# UNITED STATES PATENT AND TRADEMARK OFFICE

APPLICATION NO.	FILING DATE	FIRST NAMED INVENTOR	ATTORNEY DOCKET NO.	CONFIRMATION NO.
10/501,034	07/08/2004	Ulrich Huperz	04-370	3050
34704 7590 04/10/2007 BACHMAN & LAPOINTE, P.C. 900 CHAPEL STREET SUITE 1201 NEW HAVEN, CT 06510			EXAMINER CULBRETH, ERIC D	
			ART UNIT 3616	PAPER NUMBER
SHORTENED STATUTORY PERIOD OF RESPONSE 3 MONTHS		MAIL DATE 04/10/2007	DELIVERY MODE PAPER

<b>Office Action Summary</b>	<b>Application No.</b> 10/501,034	<b>Applicant(s)</b> HUPERZ, ULRICH	
	<b>Examiner</b> Eric Culbreth	<b>Art Unit</b> 3616

## DETAILED ACTION

Fig. 1

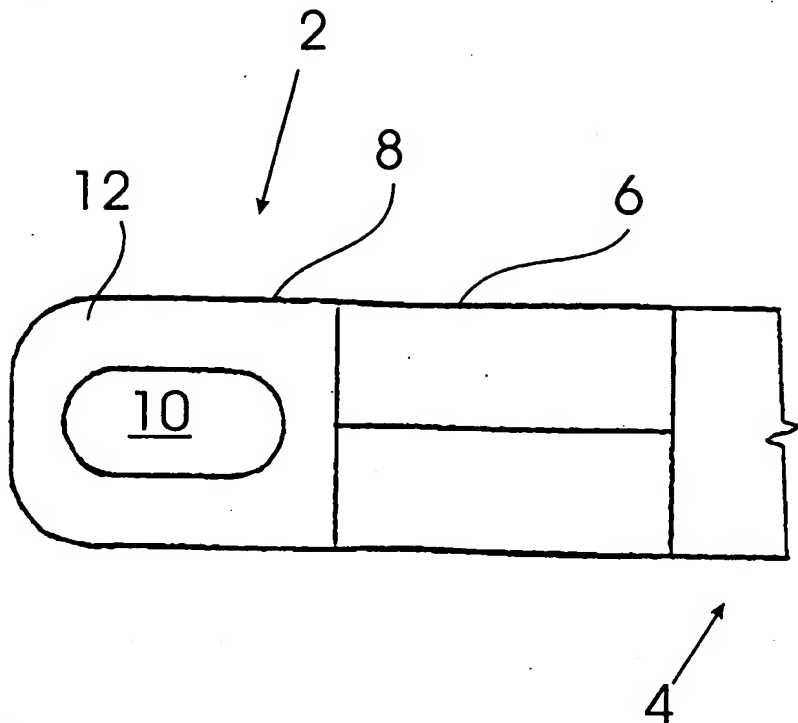
1. The drawings were received on 1/29/07. These drawings are not approved.
  - a. Figure 3 should be labeled "New Sheet" as it is a new drawing, not a replacement sheet.

- b. No description of new Figure 3 was added to the Brief Description of the Drawings or the specification (the examiner acknowledges applicant's remarks of his intention to add the references to Figure 3; still, these should be added when the figure is added).

- c. There is no support in the original drawings for the shape now shown for layer or band 14, and the lead line for 14 was to a different part in the original Figure 2.

- d. Figure 3 is new matter (there is no support from the original disclosure for the zigzagging pattern now illustrated being the mechanically interlaced limitation claimed). Also, even the showing of "interlacing" in new Figure 3 is not really interlacing (interlacing by dictionary definition is "to intertwine", "to cross one another as if woven together" and "to pass alternately over and under" (The Random House College Dictionary, revised edition © 1980); hence, the drawing still does not show interlacing as claimed).

*Not  
approved  
EC  
4/4/07*

3. To correct the drawings at this point, it is recommended that the 1/29/07 drawings be resubmitted with Figures 1 and 2 each labeled "Replacement sheet" and with new Figure 3 labeled "New Sheet". Also, in the next correspondence, a Brief Description of Figure 3 should be added in which it is stated that Figure 3 is a "schematic" or "diagrammic" representation of interlacing (meaning only a symbolic representation) and that a description of Figure 3 be added to the detailed description of the invention. And the specification should be amended to recite that the showing of the band or layer 14 in Figure 2 is a "schematic" or "diagrammic" illustration.
